X 91.119-26

MODEL 165 RX

AIR FILTER

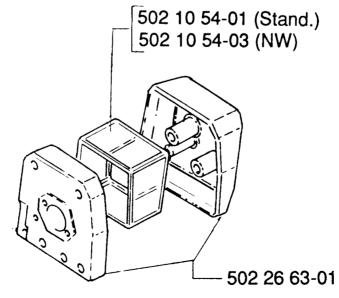
In order to obtain a better sealing between the filter holder, filter cover and airfilter the following changes have been made:

- Sealing collar on filter holder and filter cover

- Air filter with sealing

At the same time the diameter of the hole in the filter cover for adjusting the idle speed has been increased, to allow easier adjustment of the idle screw using the carburetor screwdriver. Since both the filter holder and the filter cover must be replaced when changing over to the new design these new parts are available as a kit ref. no. 502 26 63-01 filter holder, complete. Existing air filters, ref. no. 502 10 54-01 airfilter (standard) and ref. no. 502 10 54-03 air filter (NW) remain unchanged.

To simplify identification of the new air filters the air filter frame is painted grey or orange. NOTE! Use only grey or orange air filters with ref. no. 502 26 63-01 filter holder complete. These filters will also fit earlier versions of filter holder.

Introduced from serial no. 1090001.
